April 12, 2023

MGP Files: 19-2816

**RE: Copper Creek Community, Block 55 NW, City of Vaughan
Re-location of Park 'C' to buffer Humberplex residents**

Figure 1: Comparison of Park Options

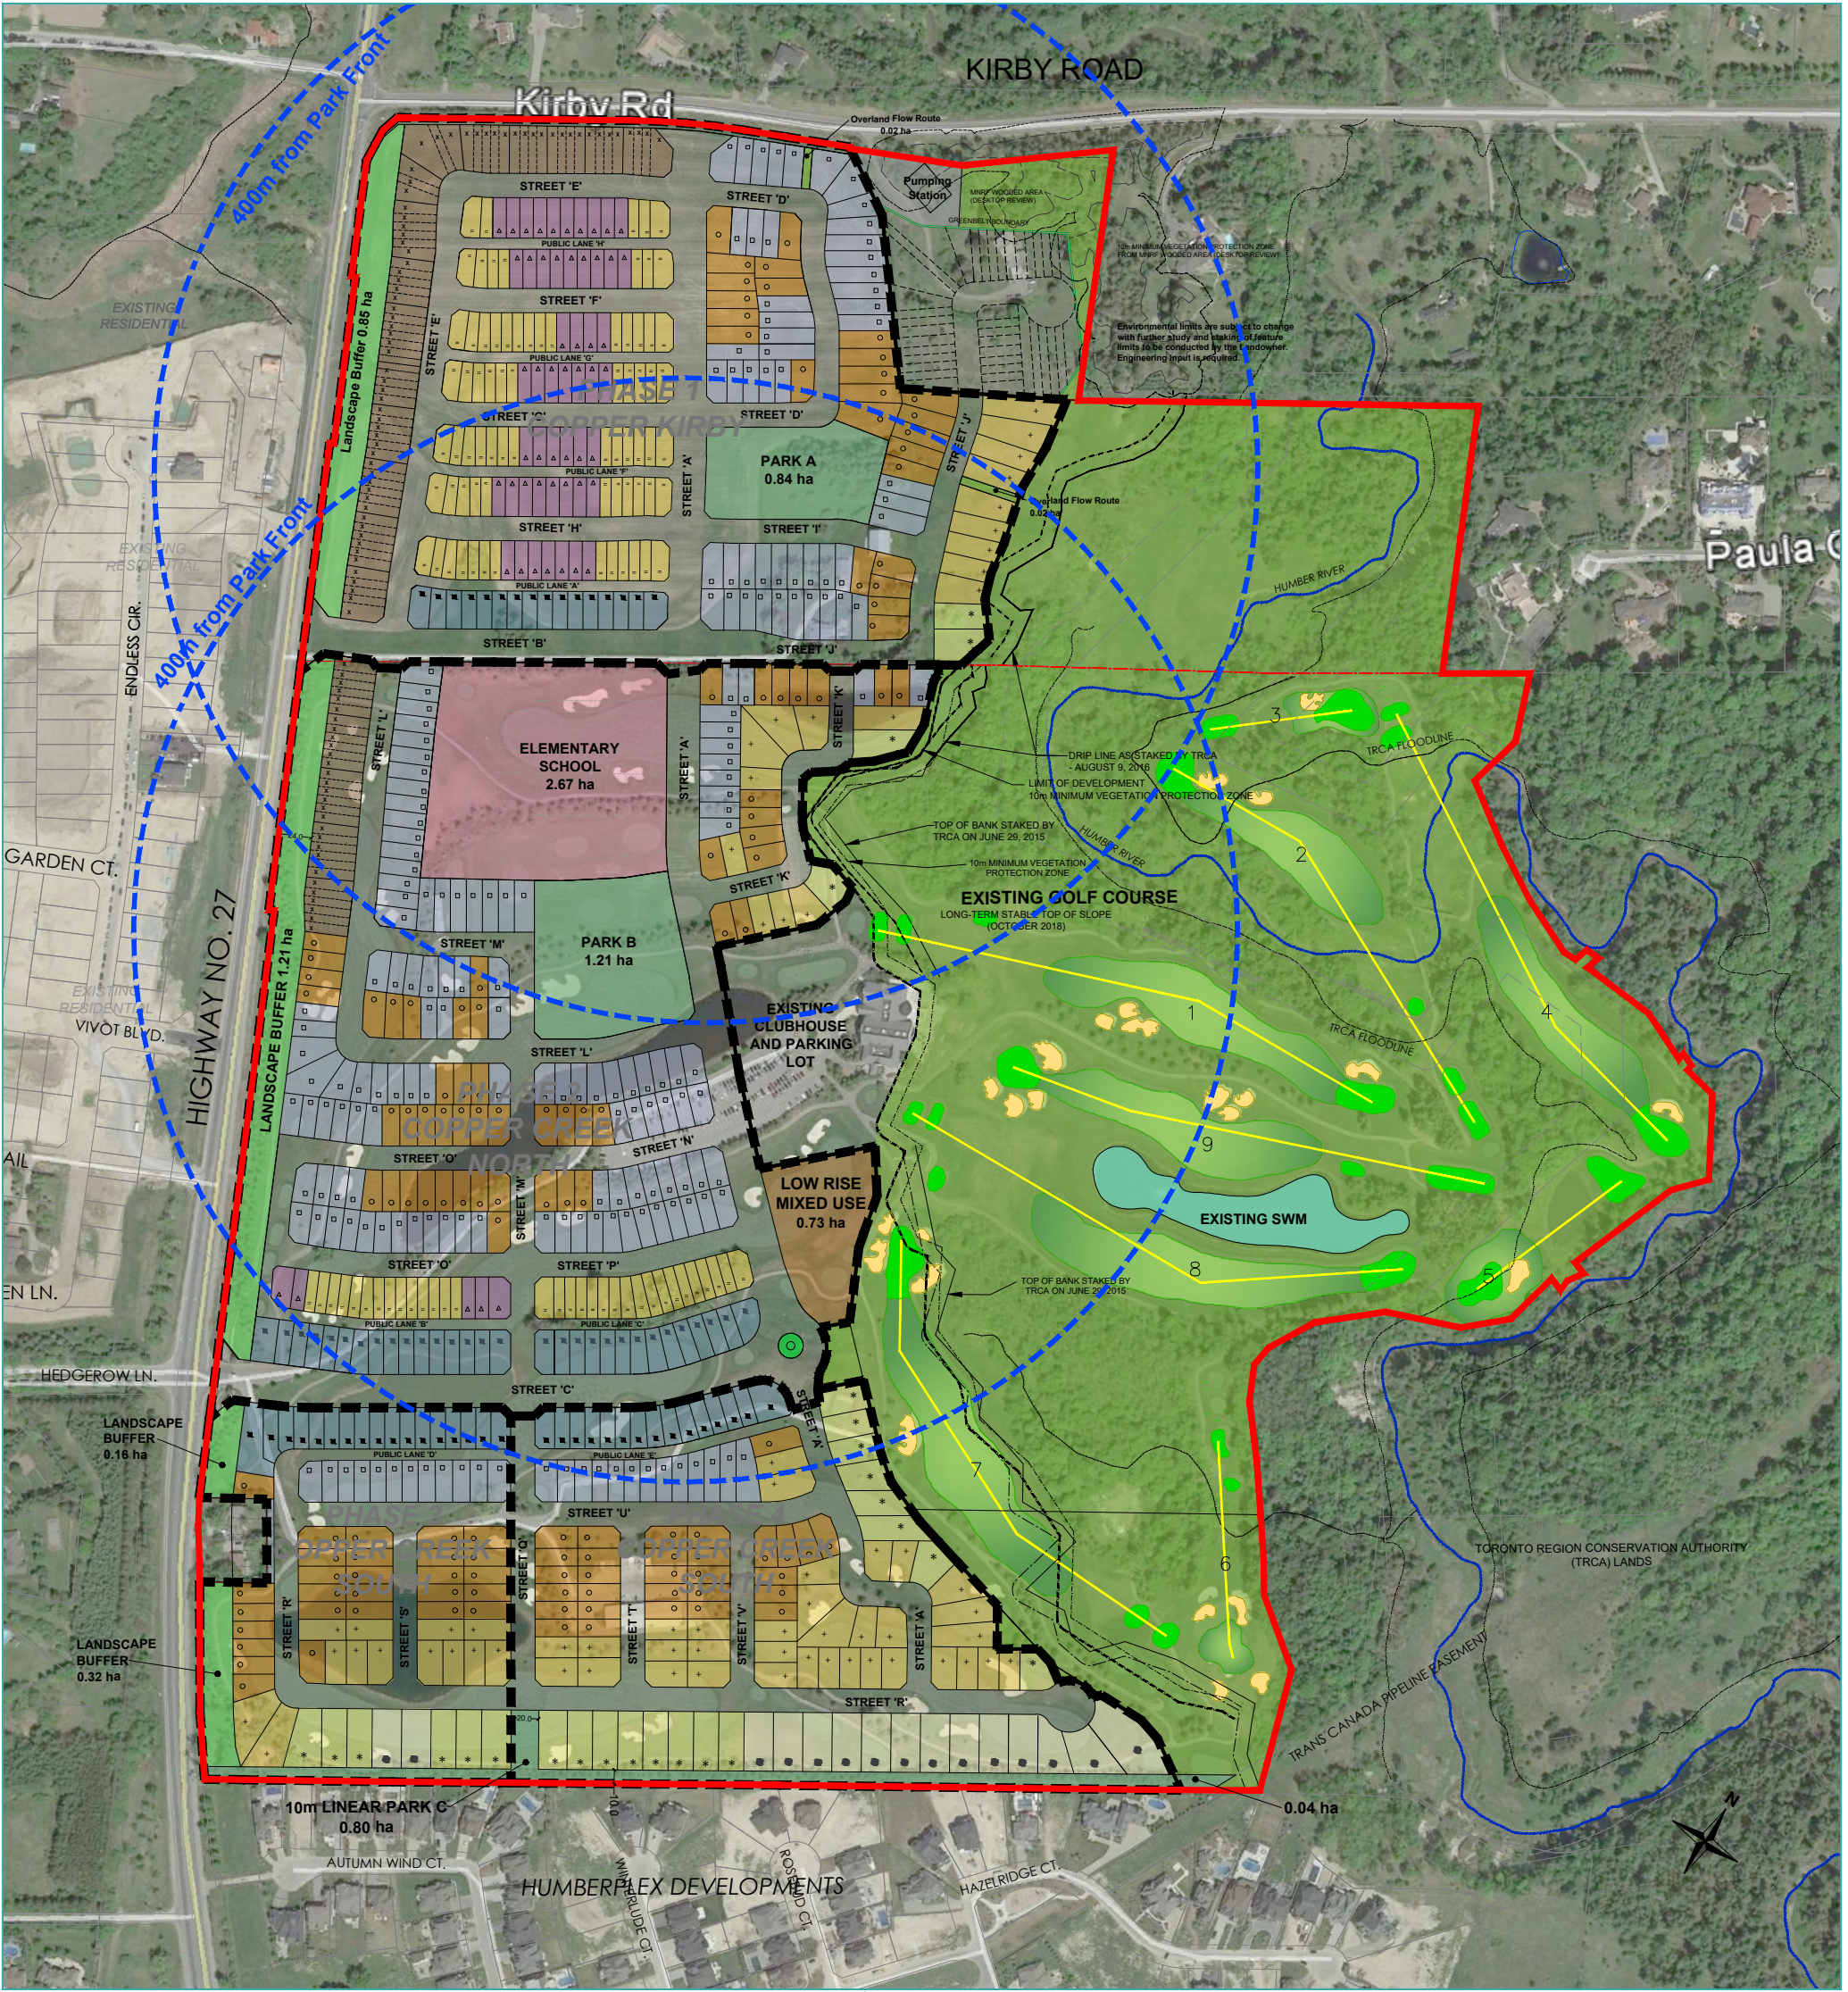
We have looked at replacing Park C with housing and adding a linear park along the southern limit of the Copper Creek Community. I have the following comments on the linear park proposal:

- The linear park will not provide amenity or play areas for the new residents.
- The elimination of Park C removes a 0.75 ha (1.8 acre) active play / open grass area from the future residents south of collector road – Street C on the Block Plan.

- The removal of Park C would result in the lower section of the block being outside of a walking distance of 400m radius from a public neighbourhood park.

- Most of the linear park will be hidden behind lots, which could present security issues for adjacent existing and future residents and does not meet the principles of Crime Prevention Through Environmental Design (CPTED). The CPTED principles include natural surveillance to create a safe and secure environment that encourages activity, vitality and viability.

- The 10m linear park width is not sufficient to protect the existing vegetation, as many of the trees will need to be removed to make room for the trail. As the trees are conifers, they can't be pruned the same as deciduous trees to allow for trails to wind between the trunks under the canopy. This reduces the effectiveness and use of the linear park to preserve the vegetation and to provide a visual buffer from new development.

- A trail system within the 10m park width will result in trails being 3 to 4m from the rear lot lines on each side which is inconsistent with Vaughan's preference for 10m between trails and lot lines.

- The linear park has limited access points: Hwy 27, one from the future subdivision road and one through the southern portion of the golf course.
- The elimination of the centrally located Park C reduces the sustainability score by 6 points, lowering it from a Silver to a Bronze score. This is itself is not good planning or community building, nor does it support the sustainability objectives of the City.

We appreciate City staff and Councillor Iafrate taking the time to hold a meeting with the residents and developer and their consultant team, but we would like to make clear that we do not support the Humberplex and area residents' proposal to add a linear park at the southern limit of the property and as a result, the removal of Park C from the plan. The linear park is not an effective use of public parkland, particularly when the City's entitlement to parkland has been reduced by recent changes to the Planning Act.

It is important to note that although the linear park is more efficient and will yield more lots for the developer, it does not represent good planning for the future community and as such, TACC is not supportive of this change.

The replacement of a large, centrally located open space, suitable for children's play equipment, shade structures, informal grassed play area and tennis courts with a linear trail intended to separate existing and new residents is not in the public interest and we cannot support that proposal.
